**Boonanarring Mineral Sands Mine
Public Environmental Review Assessment No. 1947**

**Image Resources' (the proponent's) responses to the
Office of the Environmental Protection Authority's
summary of public submissions.**

BOONANARRING PROJECT SECTION SHOWING BUFFER AND EFFECTIVE STAND OFF FROM BOONANARRING NATURE RESERVE AND MIRRABOOKA AQUIFER BOUNDARY

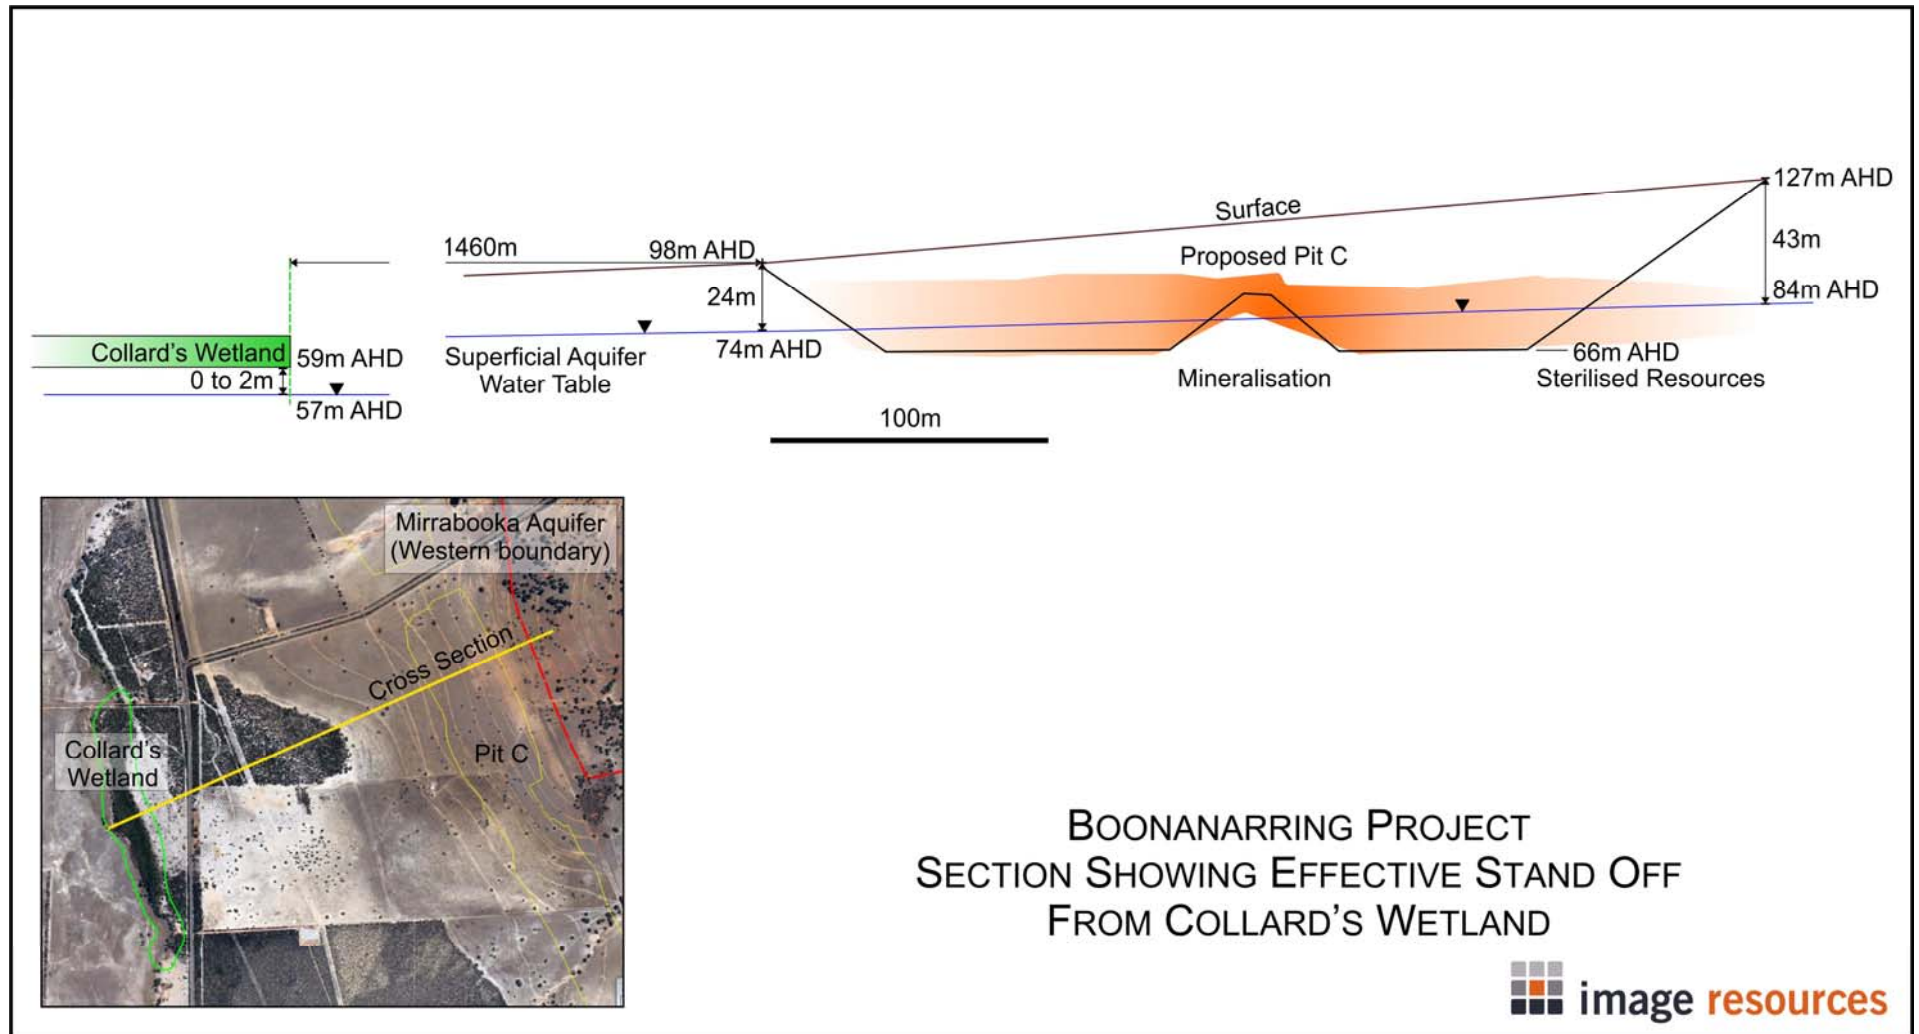
9 cont.		<p>potential impacts on wetlands should not be taken as fact. Some leakage/interaction between these aquifers should be assumed.</p> <ul style="list-style-type: none"> • The difficulty in successful artificial recharge should not be underestimated and a loss of at least 30 to 50 percent should be assumed in the water and environmental balance for the mine as it relates to the Superficial aquifer. Over time monitoring might indicate a more accurate recharge success rate or water loss percentage. • Groundwater monitoring data should be made freely available to the public, the Gingin Water Group and/or local landowners. 	<p>Given the inputs to the model are based on regional, local and preliminary data inputs (topographical, recharge, aquifer hydraulics stratigraphic and land-use) and influences on water table elevations, the model outputs reflect the broad nature of these parameters and replication of observed water table elevations.</p> <p>Further refinement of the stratigraphy within proposed development footprint and additional property zones would be required to improve the model representation of observed water table elevations; This will be presented in support of the Water Operating Strategy. At the time of model development there was no available data that could inform the distribution and hydraulics of additional property zones. An enhanced geological model may enable future model refinements in this regard.</p> <p><i>Response re: Leakage/interaction between the Mirrabooka and Superficial aquifers as it relates to potential impacts on wetlands should be assumed.</i></p> <p>Interactions between the Mirrabooka and Superficial Aquifer have been interpreted based on the available data, including records from local monitoring bores within both the Mirrabooka Aquifer and adjoining Superficial Aquifer. These interpretations are incorporated within the conceptual and groundwater flow models. The predicted footprints for the Project incorporate these interactions. The interpretations show:</p> <ul style="list-style-type: none"> • The interface between the Mirrabooka and superficial aquifers is defined by the western limits of the Kardinya Shale beds. • The interface has been interpreted in the range 100 to 600 m east of the proposed Project footprints. • To the east of the interface, the water table in the Mirrabooka Aquifer is perched above beds of Kardinya Shale. • At the interface, groundwater from the Mirrabooka Aquifer spills over the western limits of the Kardinya Shale beds; and • To the west of the interface, groundwater discharge from the Mirrabooka Aquifer recharges the Superficial Aquifer. <p>Under the described circumstances, the proposed pits would not intersect the Kardinya Shale or the Mirrabooka Aquifer. There would be no Project-related</p>

9 cont.			<p>drawdown of the water table of the Mirrabooka Aquifer. (Refer cross section figures illustrating this point, as included in Attachment B to this response to submissions).</p> <p><i>Response re: Loss of at least 30-50 % should be assumed in the water and environmental balance of the mine as it relates to the superficial aquifer.</i></p> <p>The proponent recognises that some water losses largely through evaporation would be unavoidable. The magnitude of losses would be dependent on the strategies developed to infiltrate the Superficial Aquifer groundwater.</p> <p>The proponent is aligned to groundwater management strategies that would enable no significant change to environmentally sensitive receptors. It may be preferable during the implementation of these strategies that the majority of groundwater abstracted from the superficial aquifer for pit dewatering is re-infiltrated in the vicinity of the abstraction sources. The conceptualisation and design of infiltration systems that would support a project water balance that provides no significant change to environmentally sensitive receptors is at a planning stage (Refer PER Section 1.3 and Figure 1.9).</p> <p>For the majority of the groundwater abstracted for pit dewatering, The proponent will minimise water balance deficits to the greatest extent practicable; it may be pragmatic to preferentially return it almost immediately to the mined voids that are being backfilled. At this planning stage, all infiltration designs and concepts are being considered which aim to provide the best opportunities to efficiently infiltrate the groundwater in settings compatible to the abstractions sources and close to pre-mining water table settings. The proponent will be guided by DoW's requirements in relation to this matter and will continue to inform relevant stakeholders throughout the process.</p> <p>The issues raised by the submitter will be addressed in detail through the assessment by DoW of The proponent's 5C RIWI Act licence application for dewatering.</p>
